RICHARD L. MEEHAN

June 16, 2023

Re: Dairi Prima Minerals (DPM) Mine site risks and Tailings disposal safety.
Review of Dairi 2022 EIA Addendum.

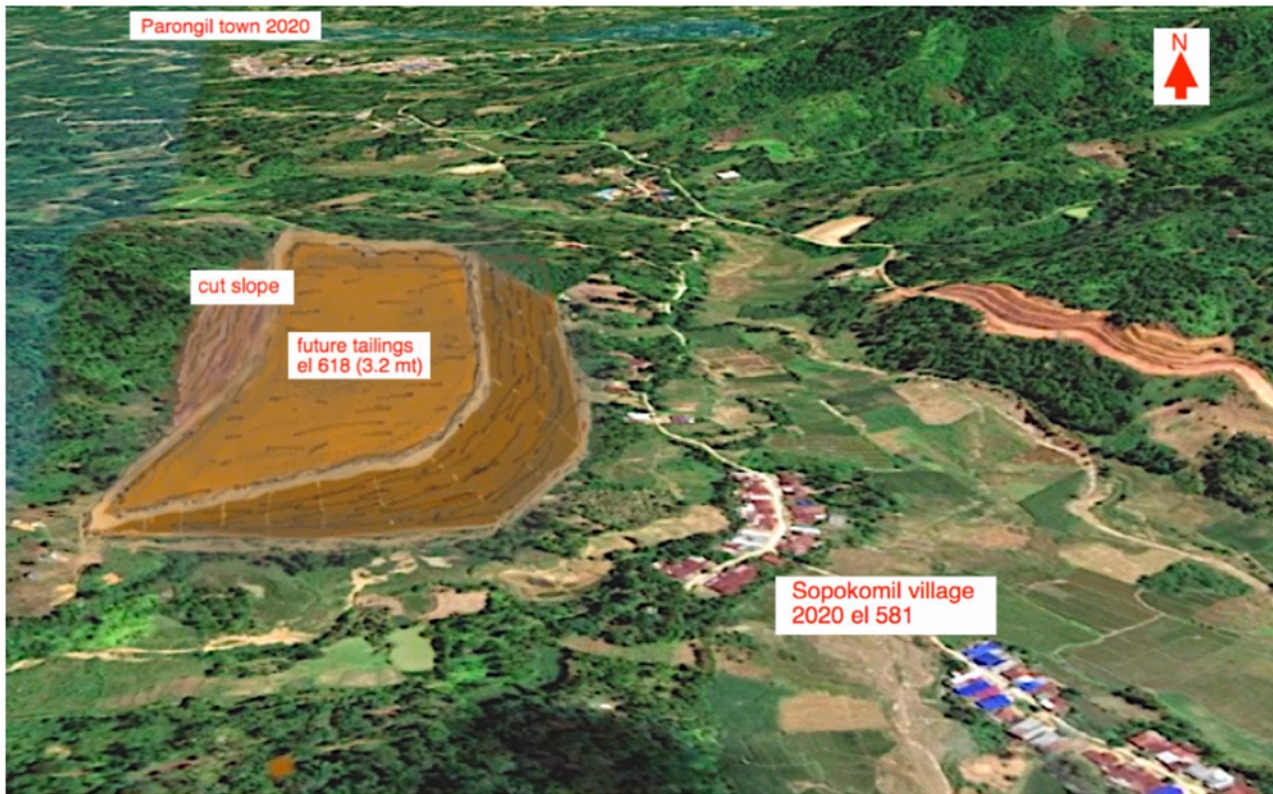
Figure 1. Planned configuration of TSF, 3.2 million tons at elevation 618. TSF configuration (brown color) from EIA Addendum fig 2.22 sketched onto Google Earth image by the author. Breach of the tailings dam above the Sopokomil village is likely in a strong earthquake because the ground between and beneath the village and the TSF and the dam foundation is unstable volcanic ash soils subject to liquefaction.

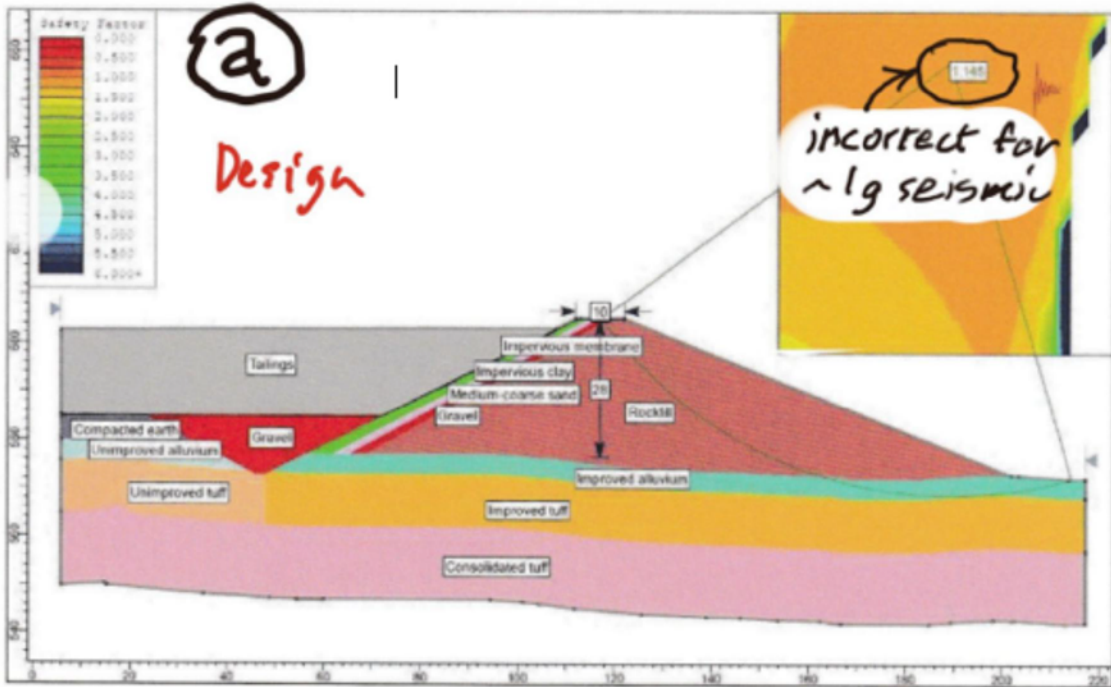
Meanwhile for this 2022 EIA Addendum, DPM, having now come to an admission of the serious seismic safety problems at the site, hired a world-class Indonesian seismologist named Danny Natawidjaja. DPM says that Natawidjaja produced a report saying ground motions with an intensity of 0.5g (.489g) are credible and must be applied at the proposed Tailings Storage Facility site. Though a copy of the Natawidjaja's report has not been made public, **I believe this 0.5g figure is intended to be applicable to bedrock 50 or more meters deep beneath the proposed dam, not to the dam foundation where the most acute and critical problems are likely to develop. Hence the Bishop method stability analysis the DPM advances (but does not document) to argue for stability is incorrect by a large margin.**

Gambar 2.47 Gambar Perhitungan Nilai FoS Disesuaikan Dengan Kondisi Akhir TSF

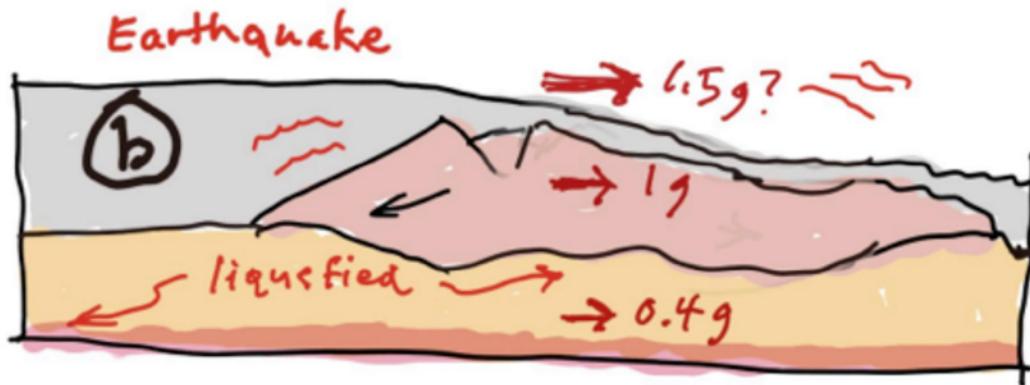
This amplification in the material overlaying the bedrock would invalidate the undocumented seismic stability analysis provided by DPM in EIA Figure 2.47. That figure concludes that the “factor of safety” (which must be more than 1.0), will be 1.03 apparently for Prof Natawidjaja's "maximum credible" earthquake of .489g. However, if site amplification is taken into consideration, the “factor of safety” for DPM’s proposed TSF would be below 1.0, down to even 0.7 (meaning the dam would be considered highly unsafe). Even lower factors of safety would occur if the dam and tailings quantities were higher than that specified in the EIA. Emerman(2023) has conducted a study of surface storage requirements for the TSF and concluded that the EIA significantly underestimates the volume and height of the required TSF. If this proves to be the case, even lower margins of safety will result.

In addition to lowering the factor of safety, failure to consider amplification also results in an incorrect failure configuration such as the one shown on EIA figure 2.47, part A. Amplified ground motion or loss of foundation bearing capacity due to liquefaction would instead flatten the failure surface in a way that causes sinking of the dam as suggested in the sketch, part B herewith.

DPM now claims, without any stated basis, (figure 2.47, extract attached) that unstable ash soil does not extend to depths greater than 16 meters. It may extend deeper, but even 16 m depth, over an area of roughly 100 x 500 m represents 800,000 cubic meters (more than a million tons) of soft volcanic soil that would need to be “improved”. This is more than the volume of the retaining rock fill dam. Removal, replacement, compaction or other form of stabilization of this amount of soil would be in an enormous task and unlikely to be implemented because it would make the project economically infeasible. There is not even any suggestion as to whether this ash *can* be improved by normal recompressive efforts, addition of chemicals, etc. In fact, the EIA Addendum elsewhere indicates that the ash is not suitable for important construction except for road fill because it is "soft volcanic eruption".
